SUNDRY NOTICES AND REPORTS ON WELLS
Do not use this form for proposals to drill or to re-enter an abandoned well. Use Form 3160-3 (APD) for such proposals.

Sotol Federal No. 9

Permanent Abandonment of Federal Wells
Conditions of Approval (LPC Habitat)

PROPOSED

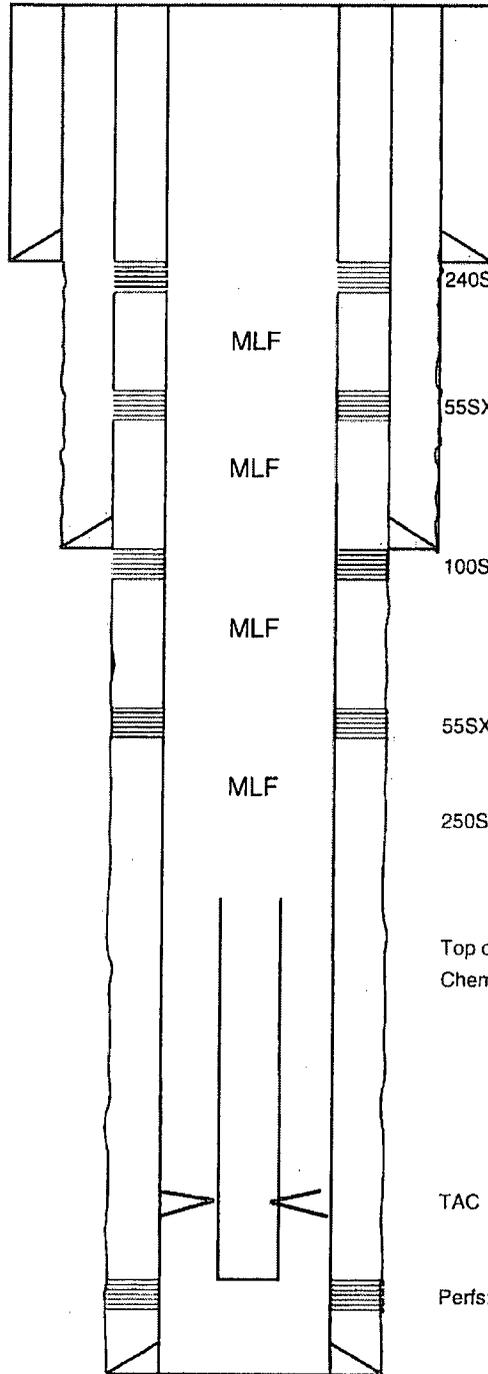
SEE ATTACHED FOR
CONDITIONS OF APPROVAL

Below ground level dry hole marker required.

6. Below Ground Level Cap (Lesser Prairie-Chicken Habitat): All casing shall be cut-off at the base of the cellar or 3 feet below final restored ground level (whichever is deeper). The BLM is to be notified a minimum of 4 hours prior to the wellhead being cut off to verify that cement is to surface in the casing and all annuluses. Wellhead cut off shall commence within ten (10) calendar days of the well being plugged. If the cut off cannot be done by the 10th day, the BLM is to be contacted with justification to receive an extension for completing the cut off. Upon the plugging and subsequent abandonment of wells that are located in lesser prairie-chicken habitat, the casings shall be cut-off at the base of the cellar or 3 feet below final restored ground level (whichever is deeper). The well bore shall then be covered with a metal plate at least ¼ inch thick and welded in place. A weep hole shall be left in the plate and/or casing.
